The Commission has issued the enclosed Amendments Nos. 142, 142, and 139 to Facility Operating Licenses Nos. DPR-38, DPR-47 and DPR-55 for the Oconee Nuclear Station, Units Nos. 1, 2 and 3. These amendments consist of changes to the Station's common Technical Specifications (TSs) in response to your request dated May 31, 1985.

These amendments revise the TSs to support the operation of Oconee Unit 3 at full rated power during the upcoming Cycle 9. The amendments change the following areas: 1) Core Protection Safety Limits (TS 2.1); 2) Protective System Maximum Allowable Setpoints (TS 2.3); 3) Rod Position Limits (TS 3.5.2); and 4) Power Imbalance Limits (TS 3.5.2).

SAFETY EVALUATION BY THE OFFICE OF NUCLEAR REACTOR REGULATION

OCONEE NUCLEAR STATION, UNITS NOS. 1, 2 AND 3

FIGURE 2.1-2C

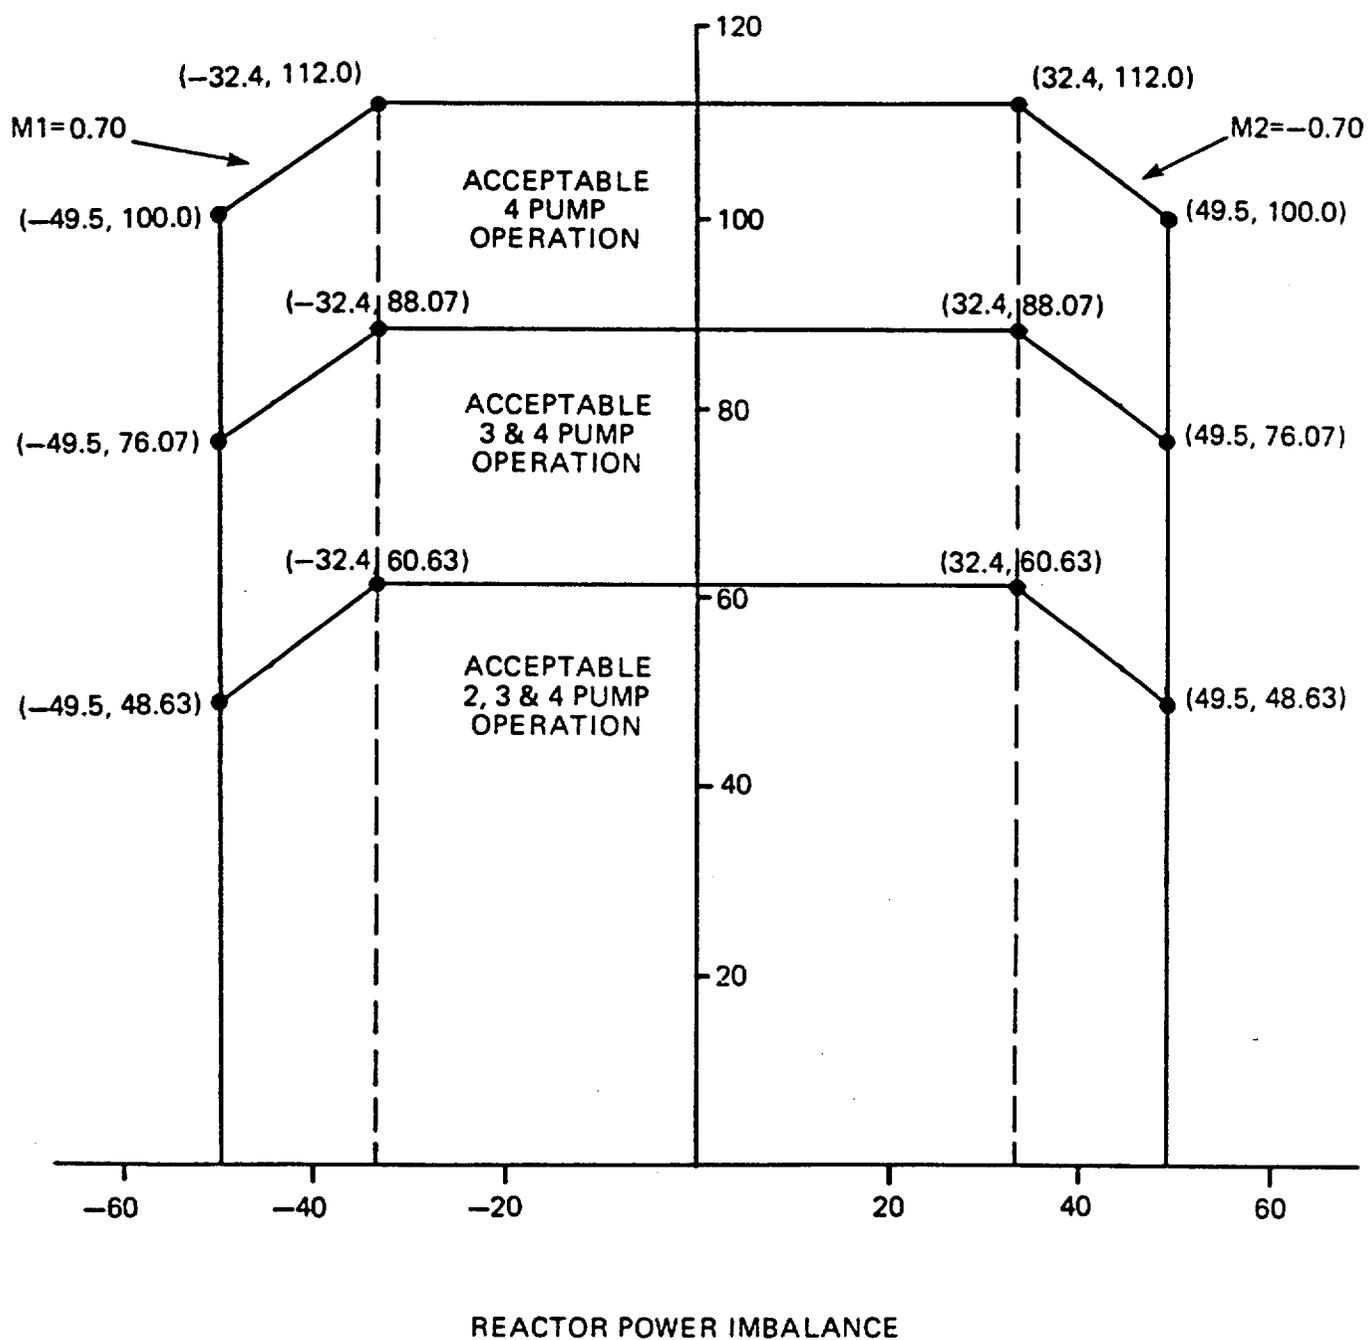
The modifications pertain to the value of the design flow (the Mark BZ assemblies have slightly higher hydraulic resistance), and the new radial and axial peaking values and the linear heat generation rates due to the use of the gray axial power shape rods. The revised Figure 2.1-2C specifies the acceptable limits of the thermal power level versus the reactor power imbalance. The analyses of the Mark BZ assemblies, the power distribution and the thermal-hydraulics have been performed with methods which have been approved and with a range of parameters which are acceptable.

FIGURE 2.3-2C

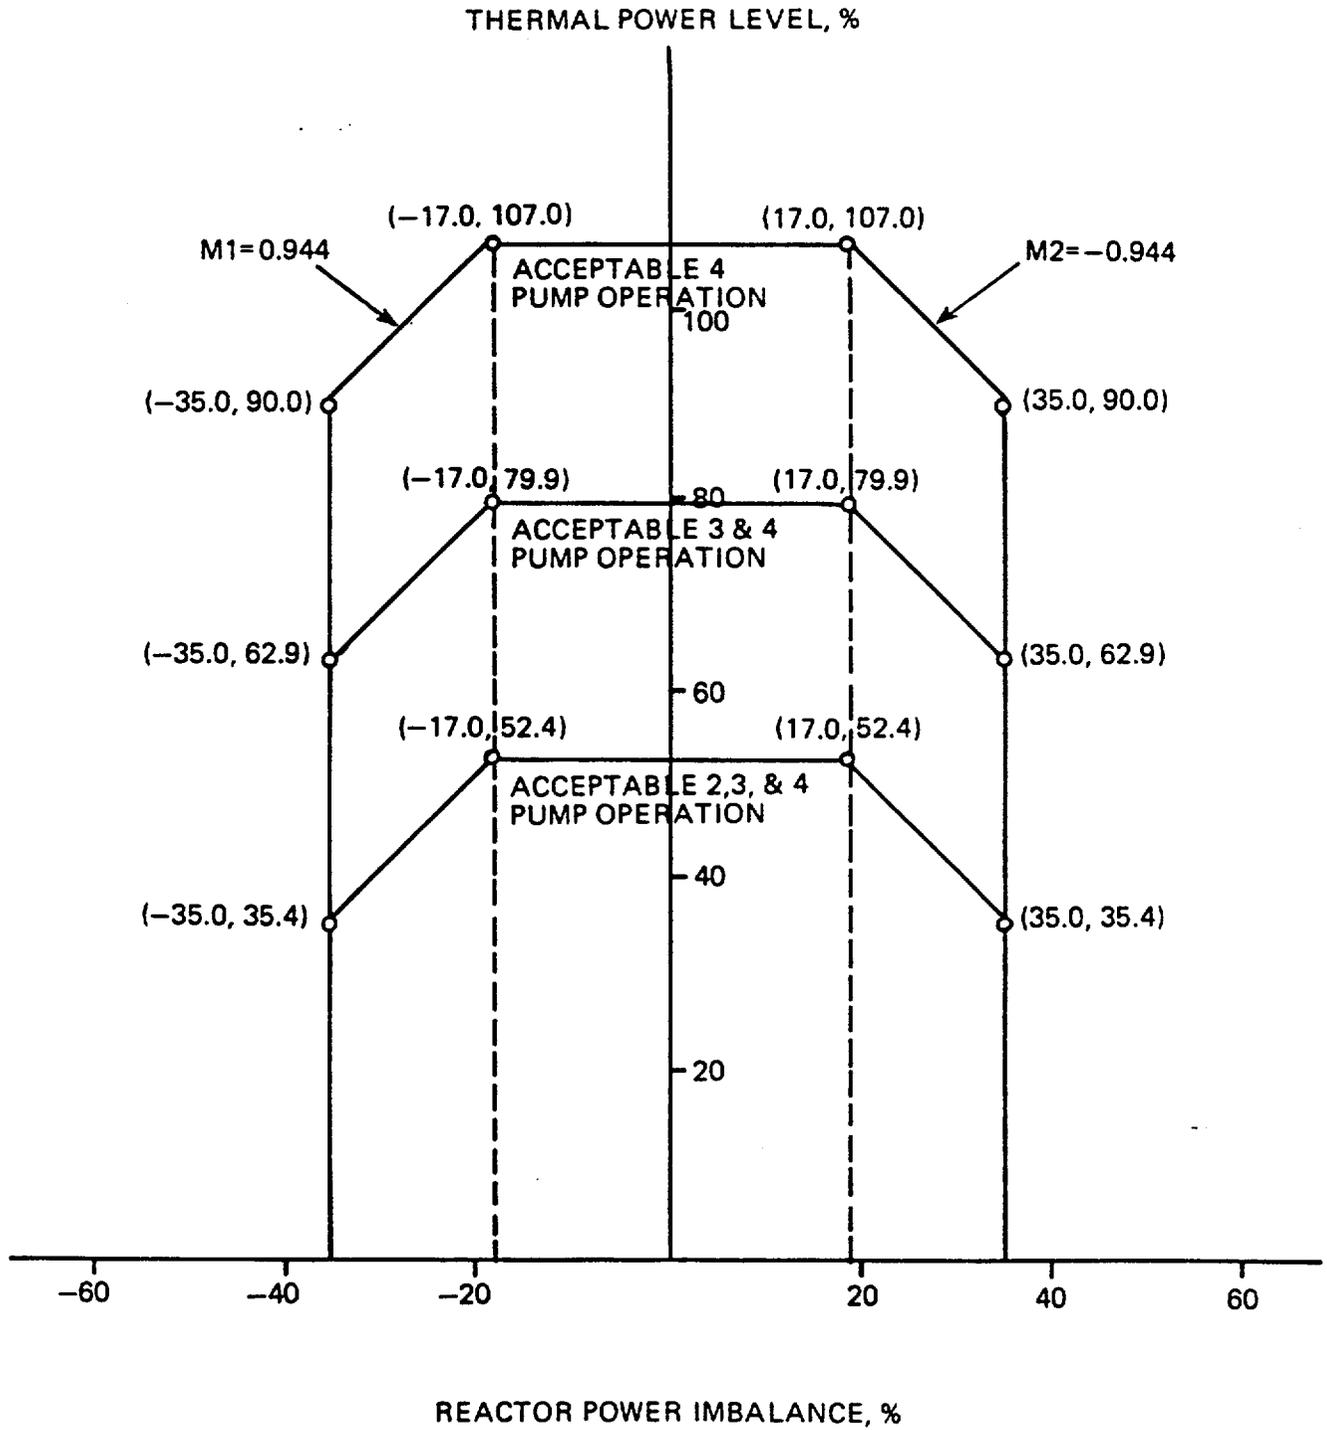
The power imbalance boundaries are established to prevent reactor thermal limits from being exceeded. The power imbalance affects the power level trip established by the power to flow ratio. The revised power level versus power imbalance limits are specified in Figure 2.3-2C. The power level and flow rates have been estimated using approved methods and acceptable parameter ranges.

Therefore, we find the specified power level versus power imbalance limits acceptable.

ROD POSITION LIMITS
 FOR FOUR PUMP OPERATION
 FROM 0 EFPD TO EOC
 UNIT 3
 OCONEE NUCLEAR STATION

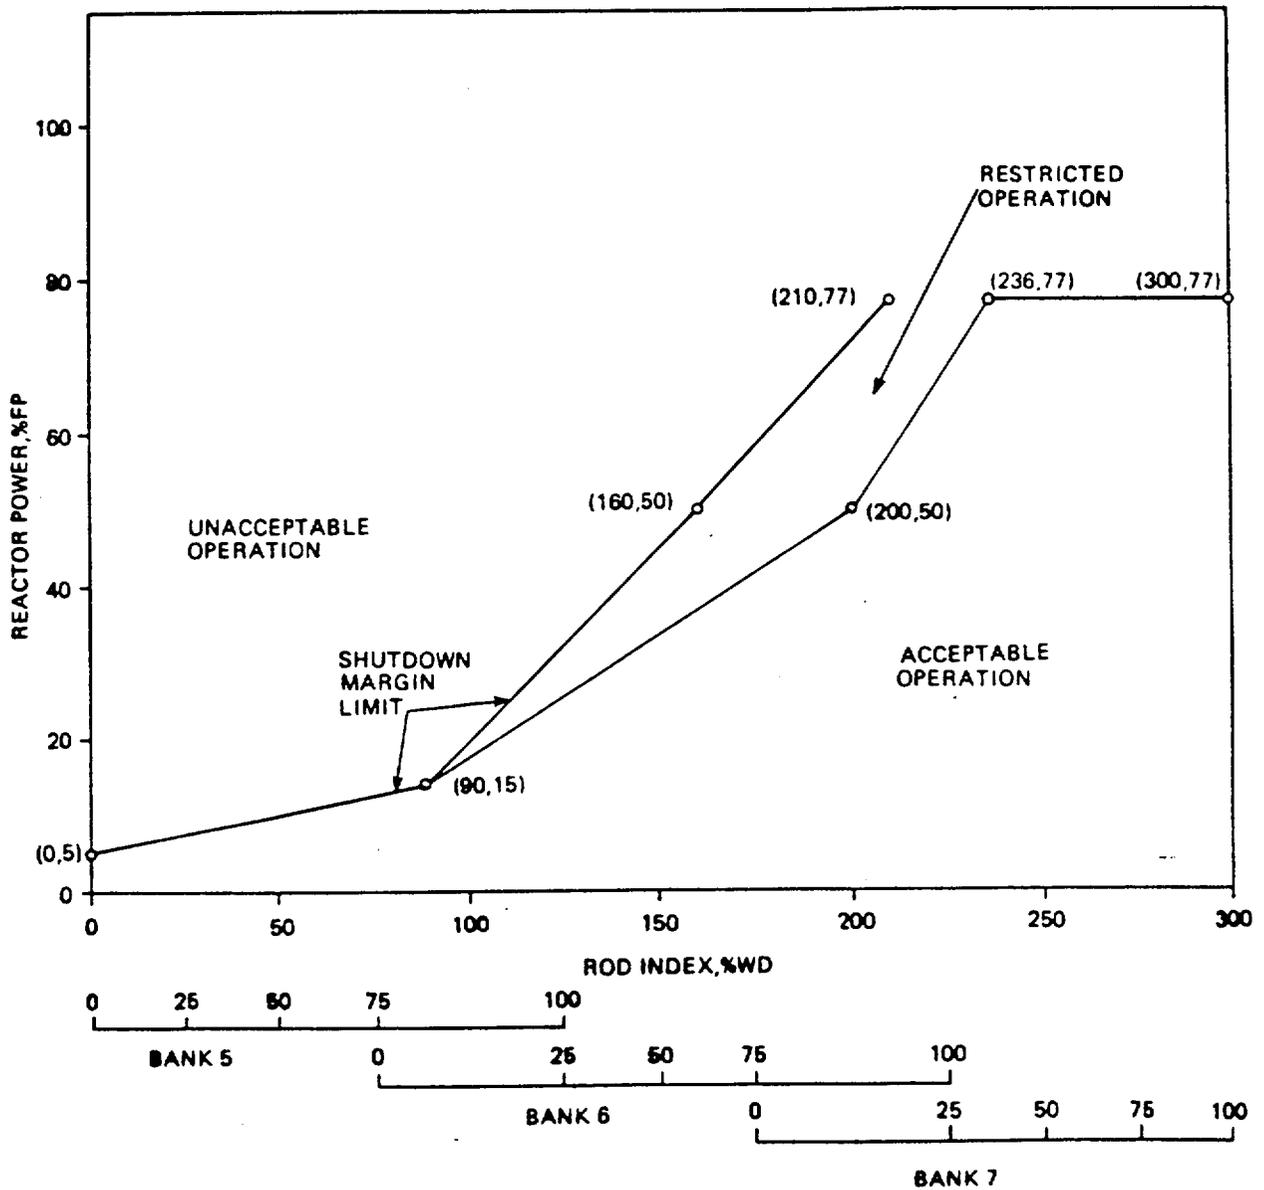
The introduction of the gray axial power shaping control rods affected the control rod position limits for two, three, or four pump operation versus burnup. The rod position limits for the axial power shaping rods are no longer needed. The proposed control rod position limits are shown in Figures 3.5.2-3, -6, -9. The operational power imbalance envelope versus burnup is shown in Figure 3.5.2-12. The nuclear characteristics of Cycle 9 have been estimated with approved codes using acceptable ranges of parameters. Therefore, we find the control rod position limits and the operating power imbalance envelope acceptable.
